Product Change Notification

■Product List Business430-18015_Packaging Specification Change of GT17HN※-4DP-2H(※)(30)

Change of Pocket Shape of Embossed Carrier Tape for GT17HN series

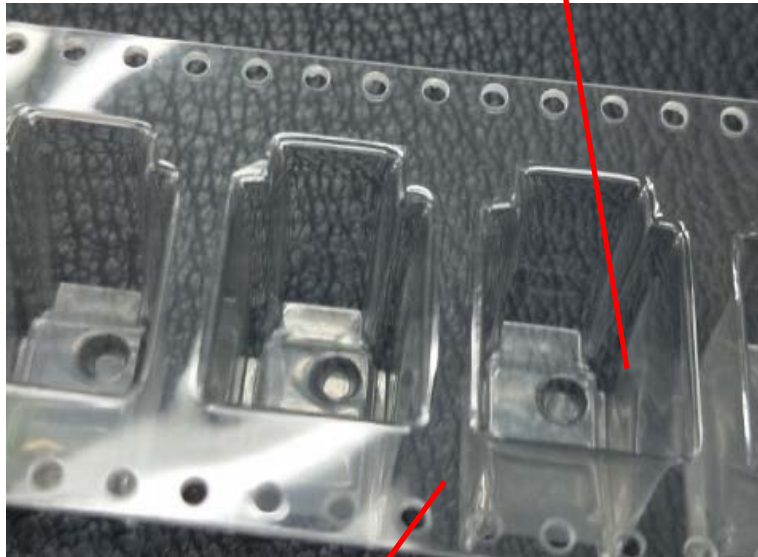
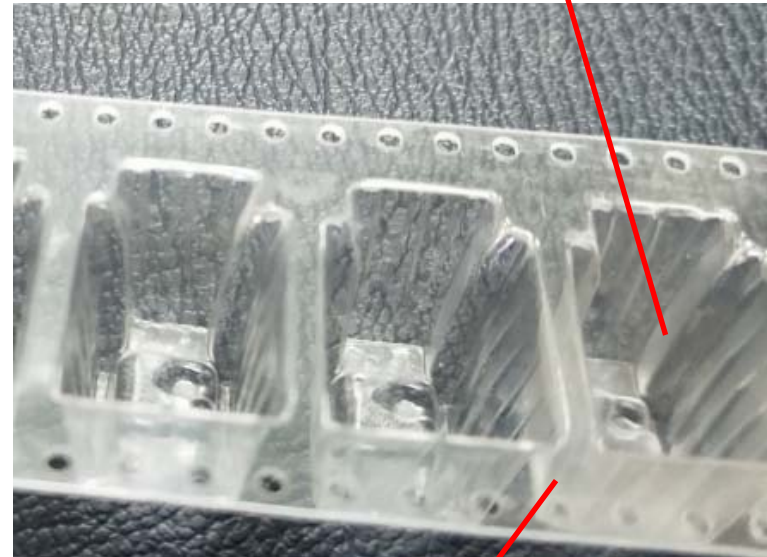
This is to change pocket shape to improve the quality for increasing strength of embossed carrier tape. Material of embossed carrier tape will not be changed, but color will become slightly translucent.

< Before change >

No reinforcement rib

Color : Transparent

< After change >

With reinforcement rib

Color : Translucent
